CITY OF ALBUQUERQUE

**RE: 7 Brew – Juan Tabo
Grading & Drainage Plan
Engineer's Stamp Date: 08/17/23
Hydrology File: H22D080**

DRAINAGE AND TRANSPORTATION INFORMATION SHEET (REV 6/2018)

**WAIVER APPLICATION FROM STORMWATER
QUALITY VOLUME MANAGEMENT ON-SITE**

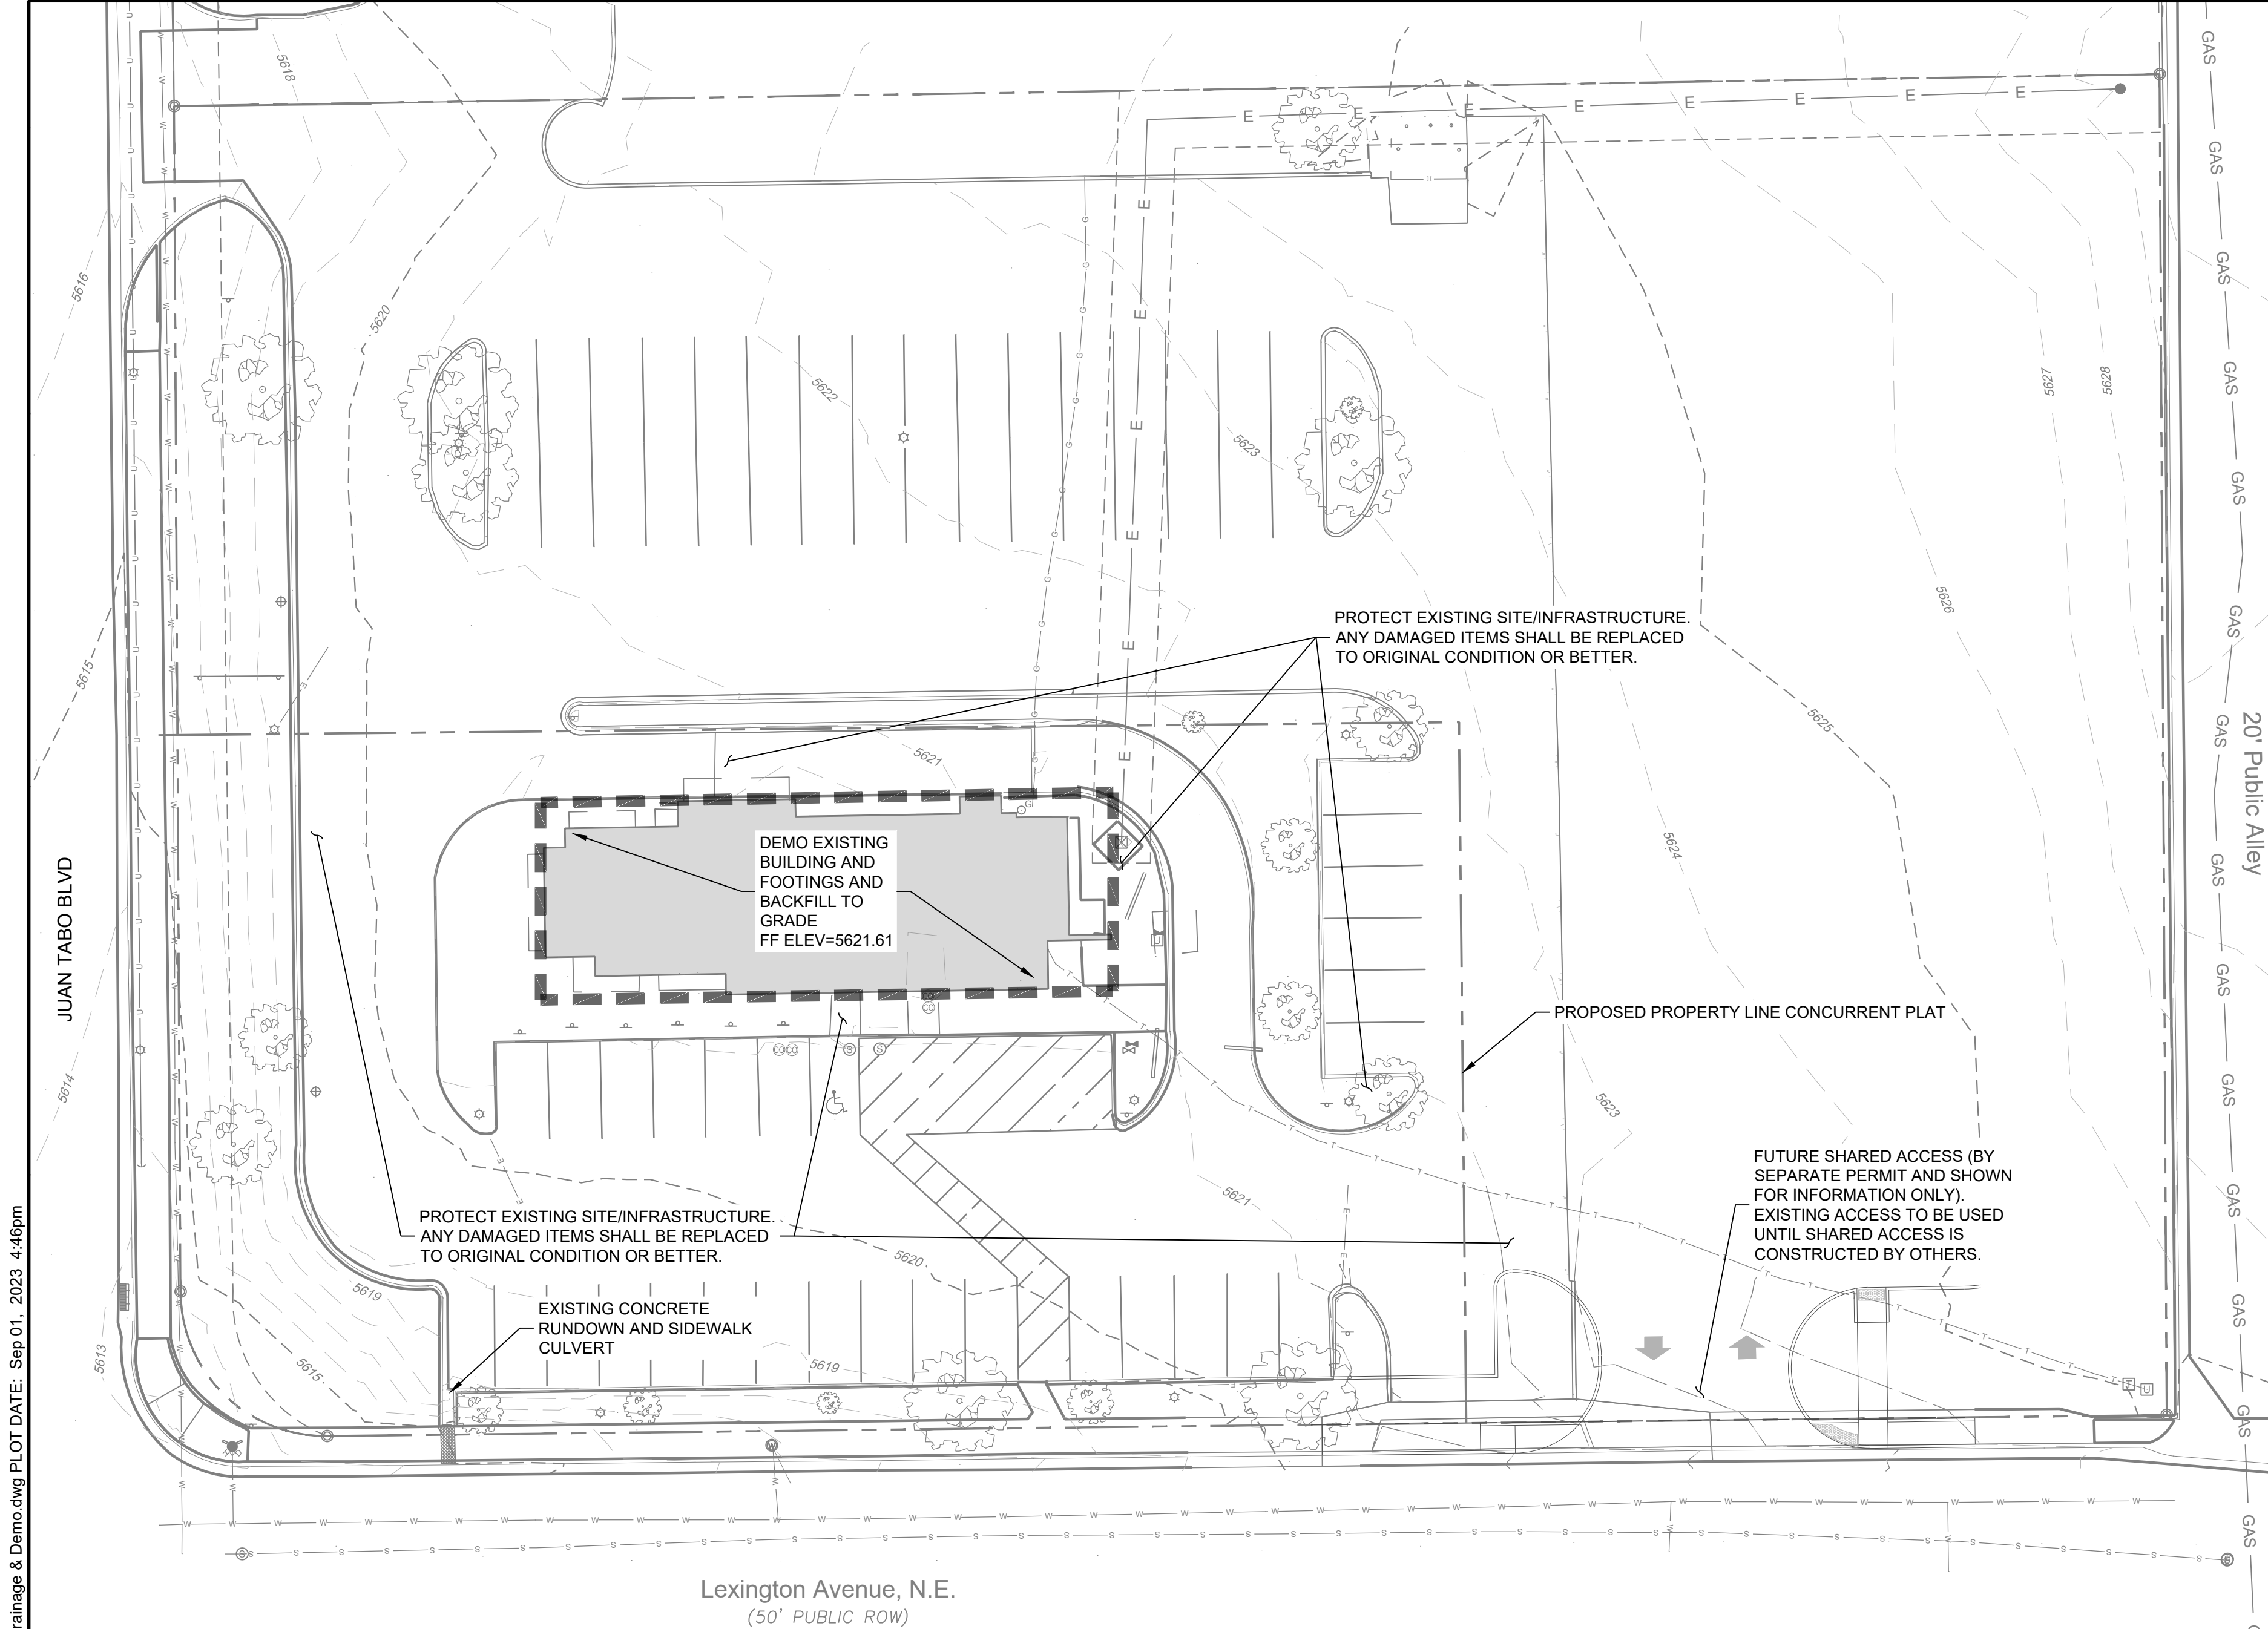
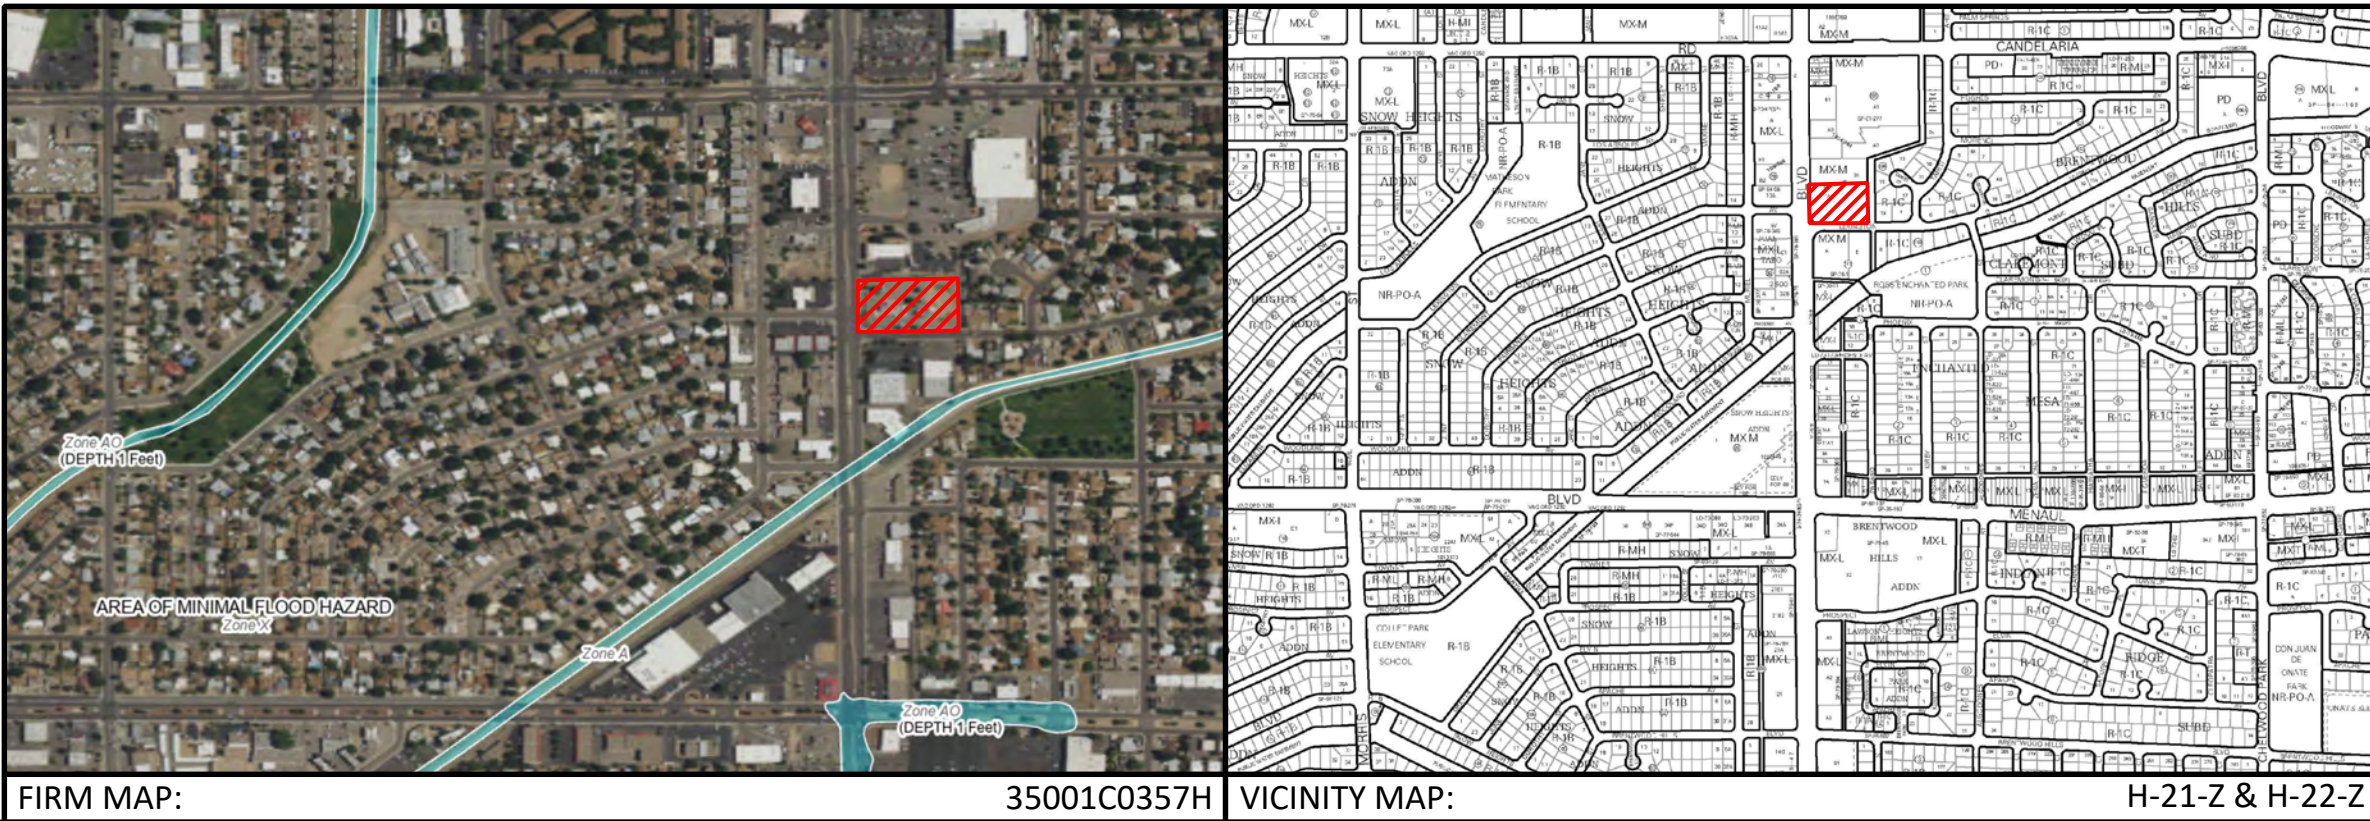
Based upon the information provided in your submittal received 06/15/2023, the Grading & Drainage Plans are approved for Building Permit and for action by the Development Hearing Officer (DHO) on Preliminary Plat/Final Plat. Please attach a copy of this approved plan in the construction sets for Building Permit processing along with a copy of this letter. **Since there will be no overall site work, there will be no certificate of occupancy requirement from Hydrology.**

Please pay the Payment-in-Lieu of \$ **3,591.47** by emailing the attached approved Waiver Application from Stormwater Quality Volume Management On-site to PLNDRS@cabq.gov. Once this is received, a receipt will then be produced and email back. Follow the instructions on the bottom of the form and pay it at the Treasury in Plaza de Sol. Once paid, please provide me proof of payment.
